CONSTRUCTION SUMMARY

Mountainview Heights 3 (G) - Russell Gardens Building Ltd.

LOT / PHASE	REG. PLAN #	HOUSE TYPE		
155 / 3	62M-1266	Mountainash Three (5 Bedroom) Elev 3

RUSSELL GARRENS  
LOT 155.

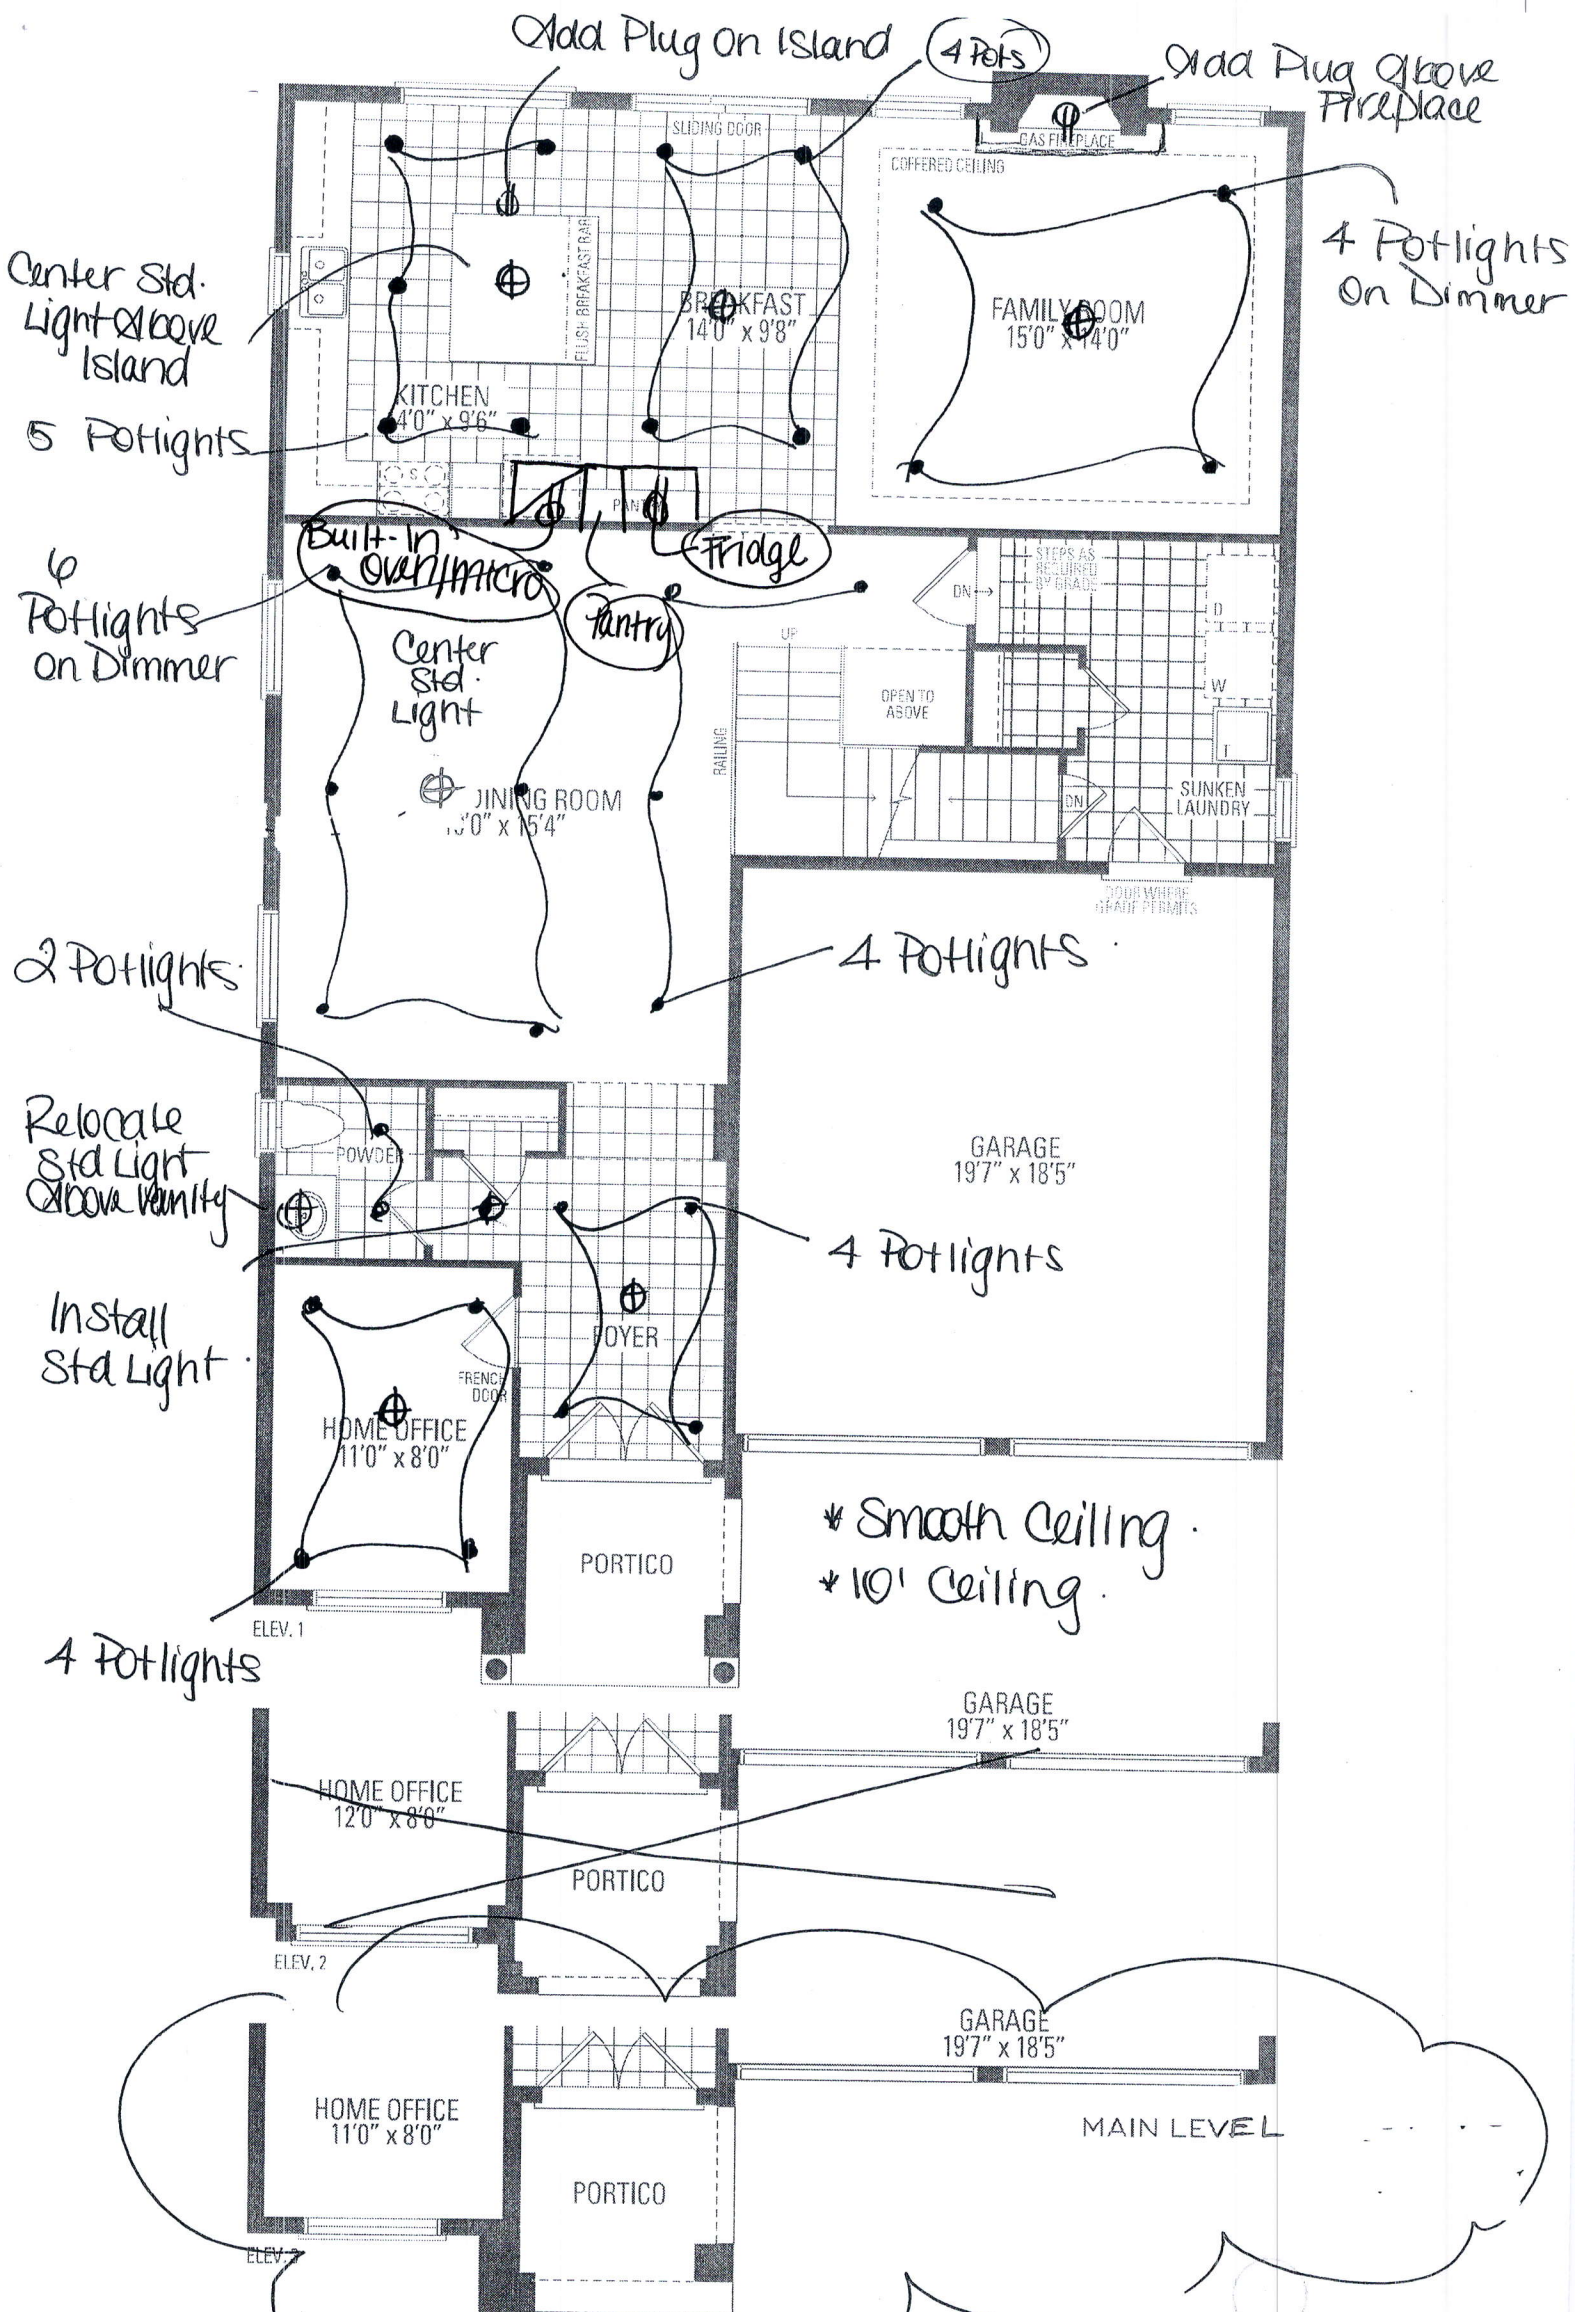
1 - KITCHEN - REVISE KITCHEN LAYOUT - SWAP LOCATIONS OF FRIDGE AND PANTRY AS PER SKETCH 18Apr22 Note:	New	★
1 - KITCHEN - RELOCATE FRIDGE TO ACCOMMODATE BUILT-IN OVEN AND MICRO 14Apr21 Note:		
1 - PLUG - ELECTRICAL PLUG - ADD TO ISLAND 14Apr21 Note:		
1 - KITCHEN - CANOPY HOOD FAN - 36" CYCLONE 550 CFM #SC50136 (GLASS CANOPY) 14Apr21 Note:		
1 - MAIN HALL - DELETE STANDARD LIGHTS TO ACCOMMODATE POTLIGHTS 14Apr21 Note:		
2 - SWITCH - DIMMER SWITCH IN LIEU OF EXISTING SWITCH - PRICE IS EACH - FAMILY ROOM AND DINING ROOM - ON POTLIGHTS ONLY 14Apr21 Note:		
2 - POT LIGHT - LED - FIRST FLOOR INSTALLATION - INSTALLED ON SEPERATE SWITCH FROM STANDARD LIGHT - POWDER ROOM 14Apr21 Note:
